**NRDC, ACEEE, and ASAP Comments on ENERGY STAR Version 7.0,
Draft 2 Specification for Televisions**

September 26, 2014

Figure 1: On mode power limit curves

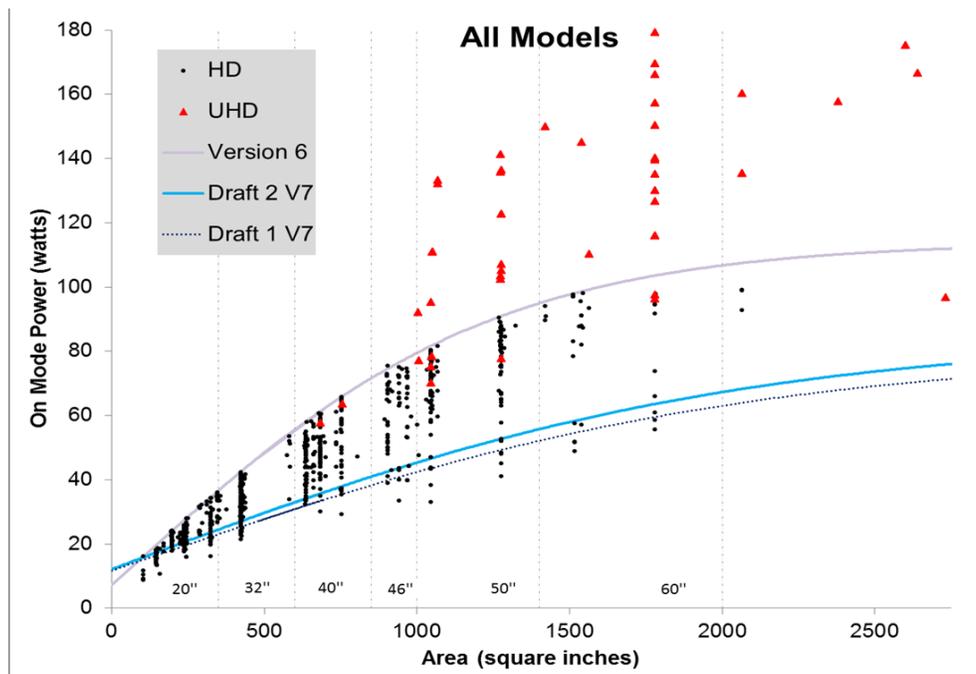
EPA re-reviewed the data set and, per their new analysis, developed a slightly less stringent Draft 2 curve (see Figure 1) to determine on mode power limits. The advocates appreciate EPA’s efforts to base its specification on the best and most recent data available. We support the Draft 2 on mode power limits and believe they will provide significant incremental savings for high definition TVs beyond those that just meet the current specification, Version 6.1.
